Project	IEEE 802.16 Broadband Wireless Access Working Group < http://ieee802.org/16 >	
Title	QoS Management Subheader for Facilitation of Uplink Scheduling	
Date Submitted	2004-08-17	
Source(s)	Yongjoo Tcha, Yong-Bum Kim, Seong-Choon Lee KT 17 Woomyeon-dong, Seocho-gu, Seoul, 137-792, Korea	Voice : +82-2-526-6155 Fax : +82-2-526-5200 mailto: yjtcha@kt.co.kr
	Jeong-Hwan Lee, Chung-Gu Kang Korea University 1.5-ka, Anam-dong, Sungbuk-ku, Seoul, , 136-701, Korea	Voice: +82-2-3290-3236 Fax: +82-2-3290-3691 mailto: ccgkang@korea.ac.kr
Re:	IEEE P802.16e/D4 Letter Ballot	
Abstract	This contribution introduces a new type of MAC-subheader QoS Management, which provides dynamic QoS parameters for uplink scheduling.	
Purpose	The document is contributed to support certain comment on IEEE P802.16e/D3 Letter Ballot.	
Notice	This document has been prepared to assist IEEE 802.16. It is offered as a basis for discussion and is not binding on the contributing individual(s) or organization(s). The material in this document is subject to change in form and content after further study. The contributor(s) reserve(s) the right to add, amend or withdraw material contained herein.

QoS Management **Subheade

~~P-37. Figure 19—Generic MAC header format~~

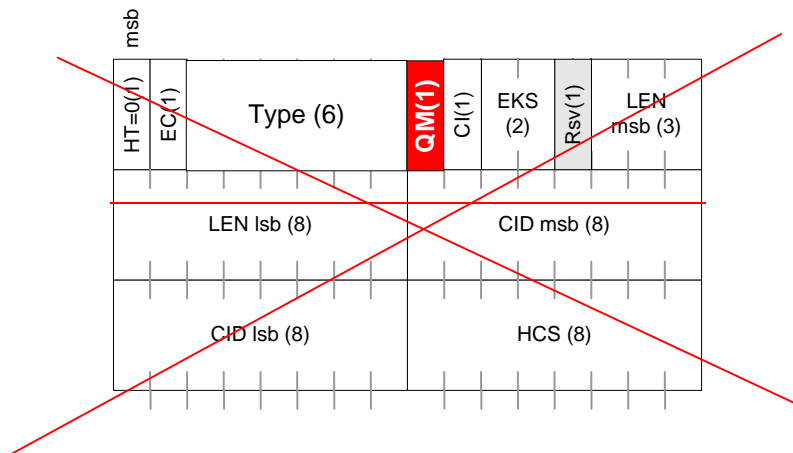
~~[Change the figure 19 in “the baseline document Section 6.3.2.1.1 Generic MAC header in page 37.”]~~
